Temperature Control — Trim Air System

Air Conditioning — Trim Air System — Conversion to the Standard 2 Zone Regulation Configuration

Service bulletin number	ZPH-21-1218
ATA chapter	21-60-11
Compliance category	sbcc02
Task category	sbtc03
Original issue date	2020-02-11

Temperature Control — Trim Air System — location, side view — Figure 1

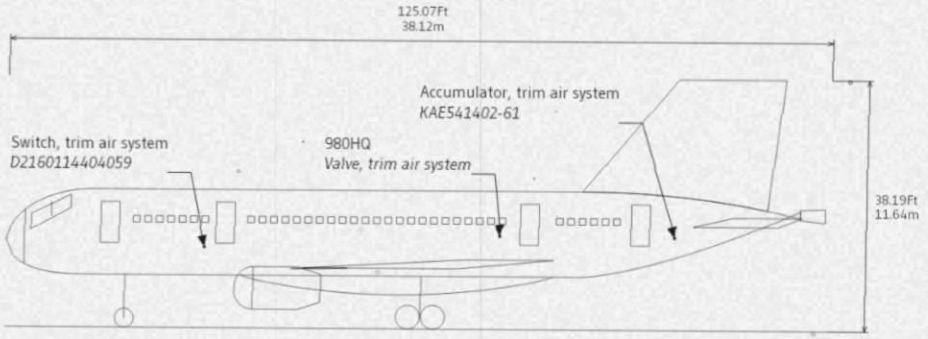
This Service Bulletin converts the trim air regulation to standard 2. Each zone valve is replaced by the switched assembly that carries a sensor boss on its outlet flange, an accumulator is installed upstream of each valve to damp pack transients, and the zone controller parameter set is re-scaled to the new loop gains. On ZEPHYR-24 aircraft a third sensing point is added for the forward zone. The distribution ducting itself is not replaced.
